Access Compliance Report

Public Rights-of-Way

Intersection ID: 24585	Main Street: REA_CROFT_DR	Cross Street: REA_RD	Location: SE
ADA ID: 519B776D9DFD	Ramp Type: Perp	Initial Pass/Fail: Fail	Overall Compliance: No
Codes/Mitigation Info/Possible Solution			Severity Score: 10
			Field Measurements/Component Compliance

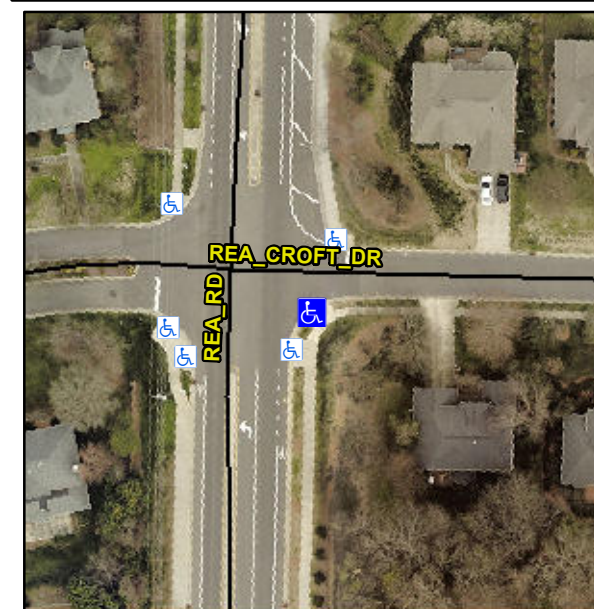
R304.5.1, R304.5.3

Compliance	Description	Data	Compliance	Description	Data
N/A	Ramp Length (in)	61.0	Yes	Ramp Slope (%)	6.6
No	Ramp Width (in)	47.0	No	Ramp XSlope (%)	3.8
N/A	Flare Type LT	N/A	N/A	Flare Type RT	N/A
N/A	Flare Slope LT (%)	N/A	N/A	Flare Slope RT (%)	N/A
N/A	Flare Traversable LT?	N/A	N/A	Flare Traversable RT?	N/A
N/A	Landing Length (in)	N/A	N/A	DWS Provided?	N/A
N/A	Landing Width (in)	N/A	N/A	DWS Contrast?	N/A
N/A	Landing Slope (%)	N/A	N/A	DWS Length (in)	N/A
N/A	Landing X Slope (%)	N/A	N/A	DWS Full Width?	N/A
N/A	Landing Curb? (Y/N)	N/A	N/A	DWS Offset (in)	N/A
N/A	Shared Landing?	N/A			
N/A	Gutter Ponding?	N/A	N/A	Gutter Slope (%)	N/A
N/A	Gutter Lip Ht (in)	N/A	N/A	Gutter X Slope (%)	N/A
N/A	Painted X Walk1?	No	N/A	Painted X Walk2?	N/A
	X Walk 1 Direction	To NE		X Walk 2 Direction	N/A
N/A	X Walk 1 Width (in)	N/A	N/A	X Walk 2 Width (in)	N/A
	X Walk 1 Slope (%)	0.5		X Walk 2 Slope (%)	N/A
	X Walk 1 X Slope (%)	4.7		X Walk 2 X Slope (%)	N/A

Remove & Replace Entire Ramp.
